**Notice of Meeting for the  
Historic and Architectural Review Commission  
of the City of Georgetown  
January 14, 2021 at 6:00 PM  
at Teleconference**

**Public Hearing** and **Possible Action** on a request for a **Certificate of Appropriateness** (COA) for the addition of awnings or canopies and replacing a historic architectural feature with a non-historic architectural feature at the property located at 119 W. 7<sup>th</sup> Street, bearing the legal description 0.083 acre, being the West 30 feet of Lot 1, Block 38, Original City of Georgetown. – Britin Bostick, Downtown & Historic Planner

# Planning Department Staff Report

**FRONT ELEVATION** SCALE 1/4" N/A

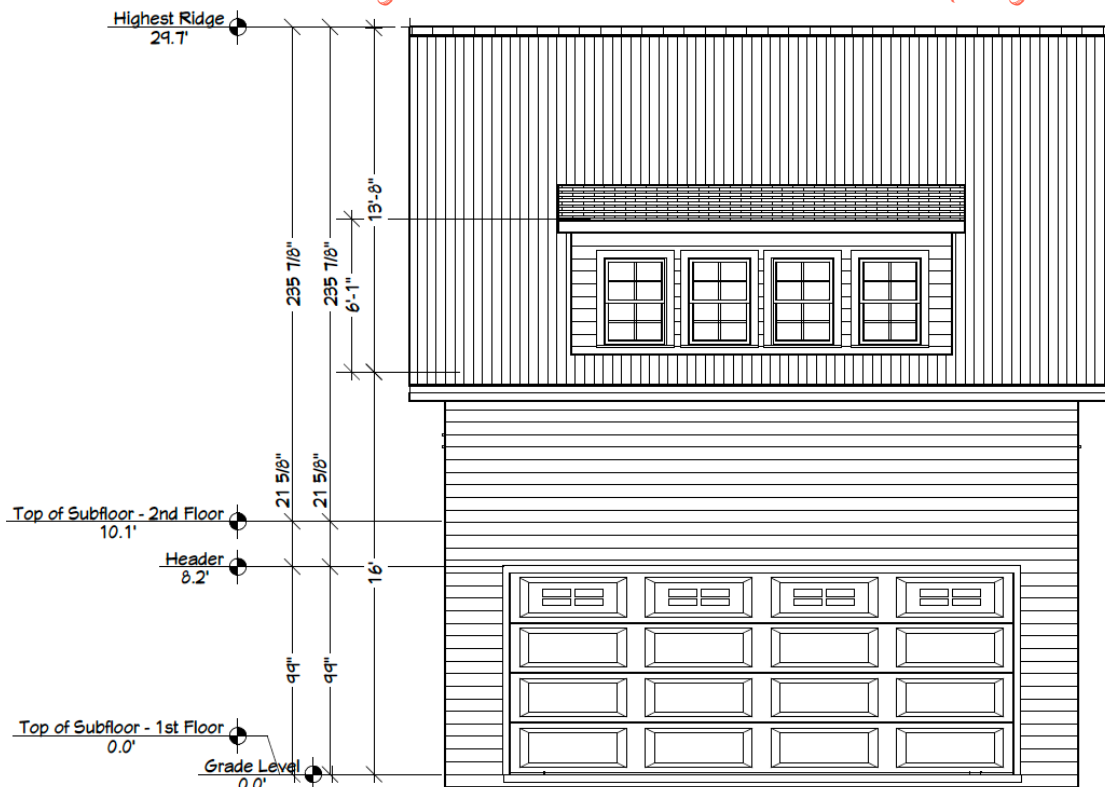
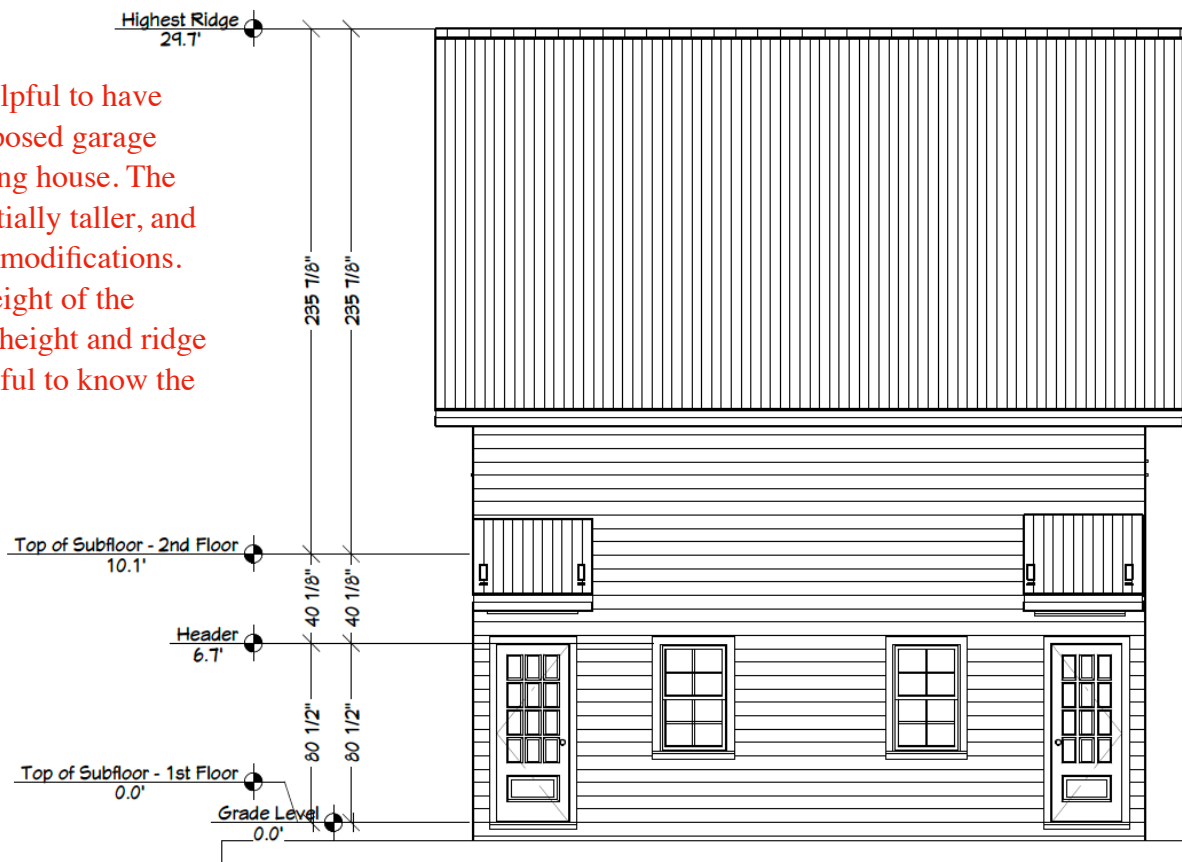
**Britin asked:** It would be helpful to have elevations that show the proposed garage addition relative to the existing house. The garage appears to be substantially taller, and requires two building height modifications. Is it possible to reduce the height of the garage by lowering the eave height and ridge height? It would also be helpful to know the height of the existing house.

**Builder reply:** We can modify the height if needed without taking too much away from 2nd floor. Lets see what the verdict is first from HARC.
